# Holland & Knight

## Memorandum

Re: **Dezer Intracoastal Mall LLC / Intracoastal Mall Redevelopment  
3501 Sunny Isles Blvd., North Miami Beach, Florida (Item # 19-3)**

**Response to TRAD Comments Dated March 26, 2020,  
and Supplemental Planning and Zoning Comments Received on May 18, 2020**

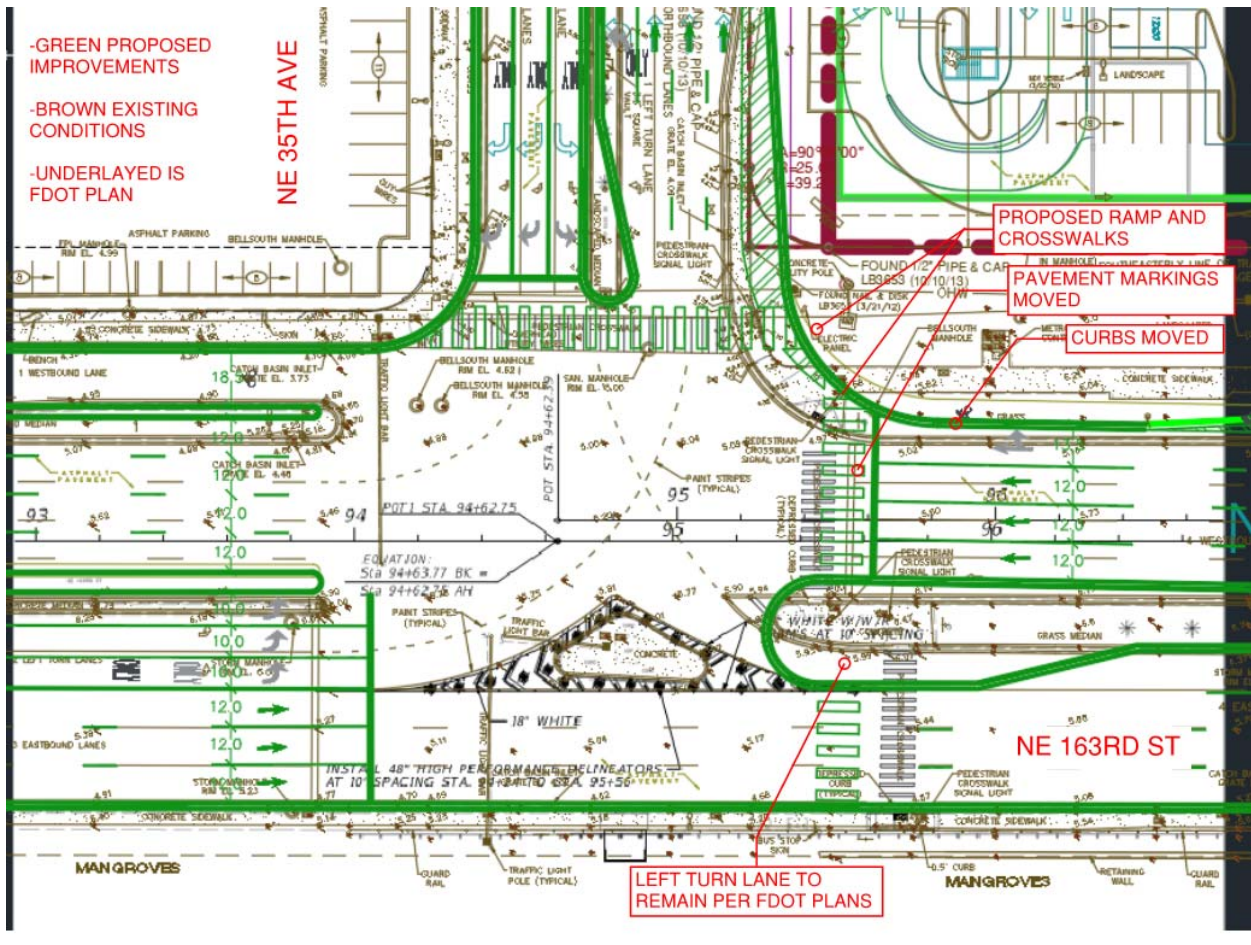
4. Did the Developer's Consultant (Langan) communicate with the FDOT project engineers as relates to coordinating any new turn lanes, or roadway modifications, etc., as to the impact of their upcoming roadway project and any possible moratoriums? I had provided the FDOT contact info on an email to Michael Carr of Langan on January 23, 2020 subsequent to a Utility Coordination meeting with the FDOT for their project? The FDOT project for SR 826 (FP # 436525-2-52-01) includes some redesign work between NE 35 Avenue and SR A1A as well as the bascule bridge refurbishment. The project is scheduled to be let by FDOT in the Fall of 2020.

**Response: Applicant is coordinating with FDOT. The enclosed plan incorporates the proposed improvements. Below is an overlay of the two projects. Minor revisions to Applicants' plans will be made after the FDOT construction has been completed and the project is submitted for site plan approval. The dark green represents the Applicant's current plans and the brown is the FDOT proposed plan.**
